**—WESTERN V400 SKEET RELEASE—**

**WINCHESTER GROUP  
OLIN CORPORATION**  
EAST ALTON, ILLINOIS 62024-1174

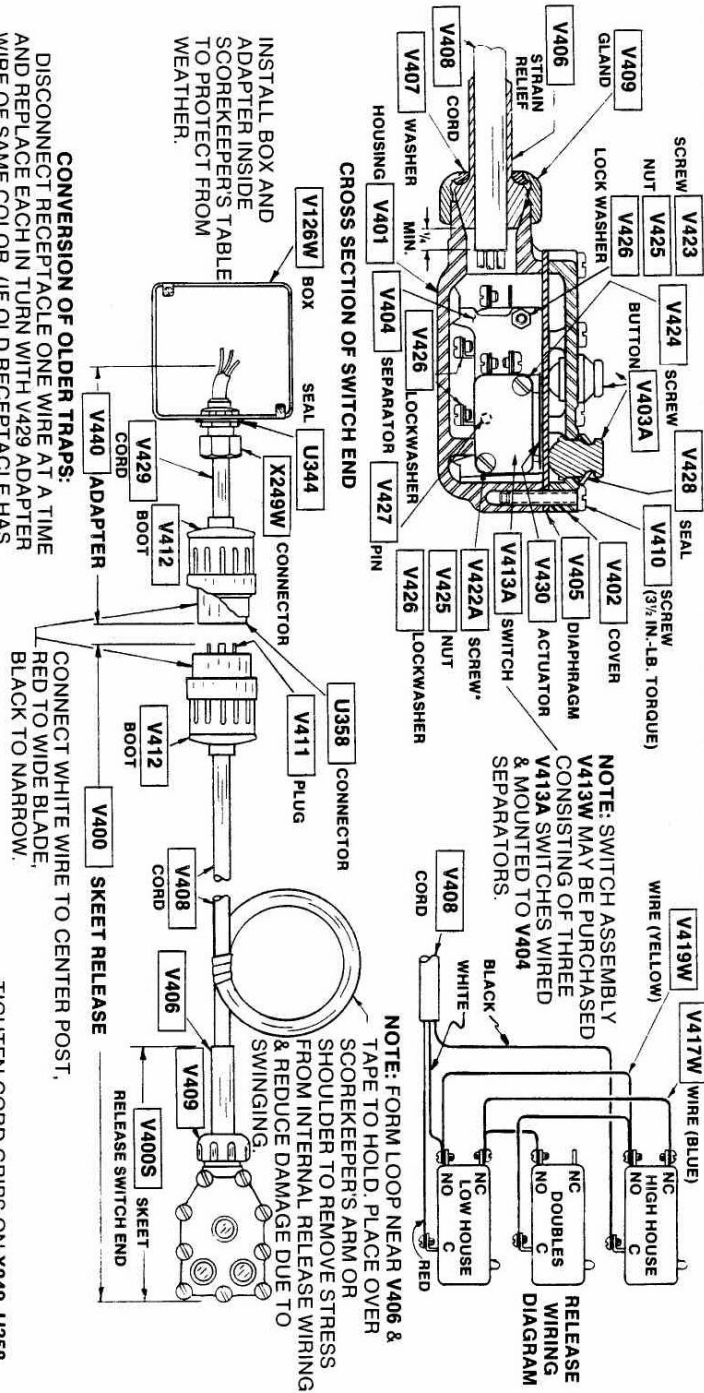
**CONVERSION OF OLDER TRAPS:**  
DISCONNECT RECEPTACLE ONE WIRE AT A TIME AND REPLACE EACH IN TURN WITH V429 ADAPTER WIRE OF SAME COLOR. (IF OLD RECEPTACLE HAS GREEN WIRE, REPLACE WITH RED ADAPTER WIRE.) CHECK WIRING WITH DIAGRAM FURNISHED WITH TRAP.  
WRAP ALL WIRE NUTS WITH AT LEAST TWO LAYERS OF PVC ELECTRICAL TAPE.  
WHEN REPLACING OLDER ZIW RELEASE UNITS (METAL-TWO SWITCH) WRITE PRODUCT SERVICE DEPT. FOR NECESSARY TRAP INTERNAL CHANGE INSTRUCTIONS.

\* SINGLE 1/4" LONG SCREW & SPACER OF EARLIER MODEL HAS BEEN REPLACED WITH TWO 3/8" LONG SCREWS, NUTS & LOCKWASHERS.
